Origination Form
Proposed Revisions to a Standard Plans Index

Originator:	Behring, Zachary	Index Number:	641-020
Date:	6/17/2026	Sheet Number(s):	1 ,3
E-mail:	Zachary.Behring@dot.state.fl.us	Index Title:	Concrete CCTV Pole

Summary of the changes:

LAST REVISION		DESCRIPTION:	FDOT		CONCRETE CCTV POLE		INDEX	SHEET
11/01/22		11/01/26	FY 2026-27 STANDARD PLANS				641-020	1 of 5

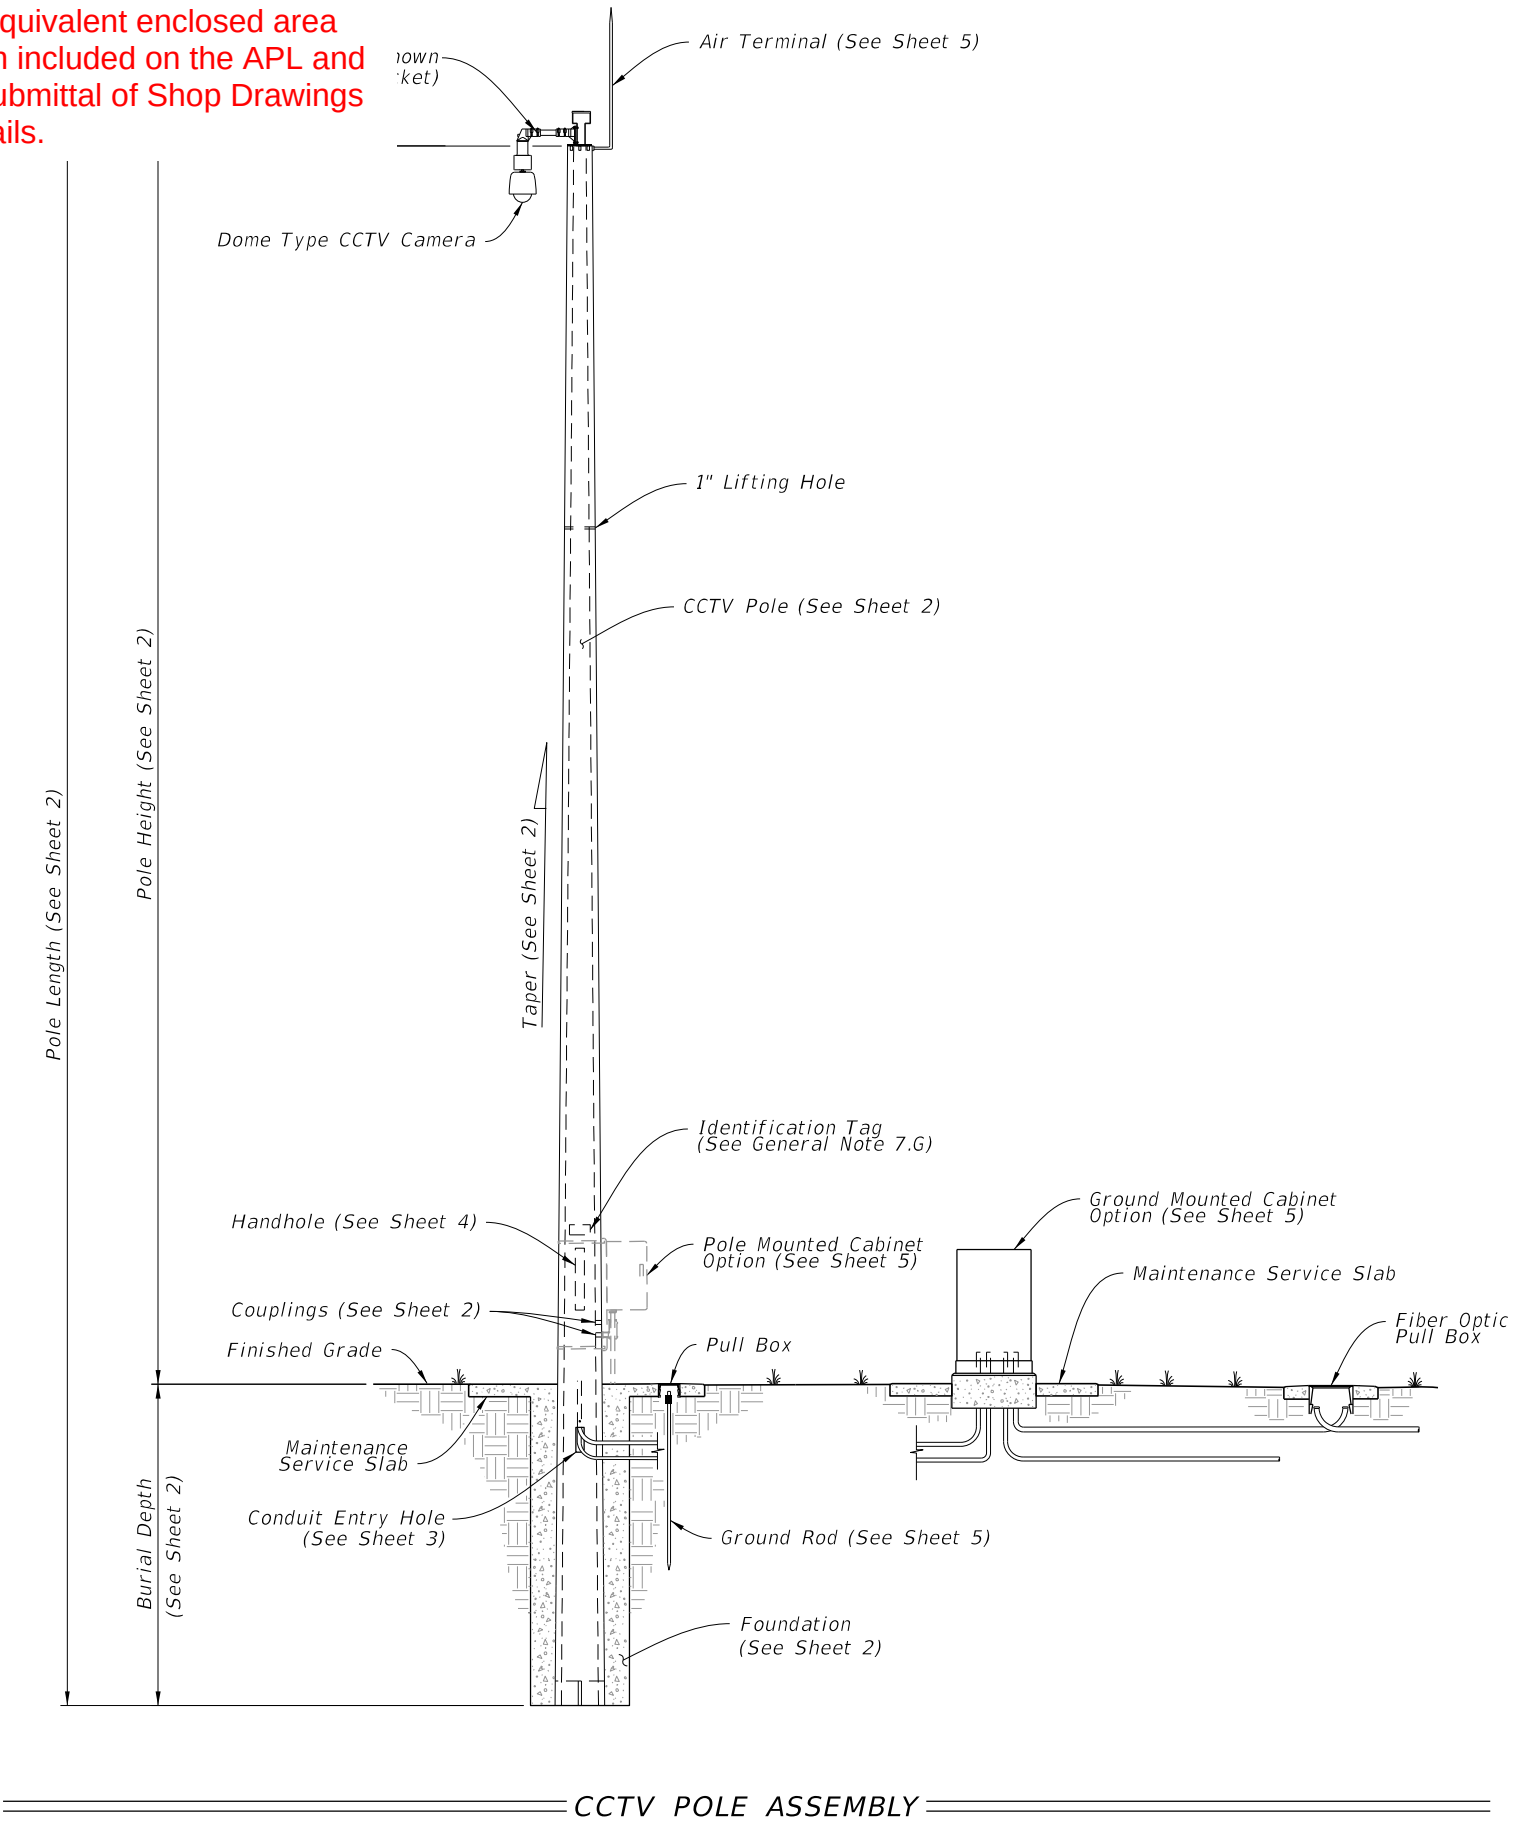
Sheet 1: Updated General Note 2 to include "Alternate Multi-sided void form shapes with an equivalent enclosed area are allowed when included on the APL and will not require submittal of Shop Drawings for matching details.
Sheet 3: Added Note "(Circular void shown, multi-side void similar. See General Note 2)" under the 12-SIDED CONCRETE POLE and ROUND CONCTETE POLE details.

Fabricators have expressed an interest in using multi-sided void forms

UPDATED: Alternate multi-sided void form shapes with an equivalent enclosed area are allowed when included on the APL and will not require submittal of Shop Drawings for matching details.
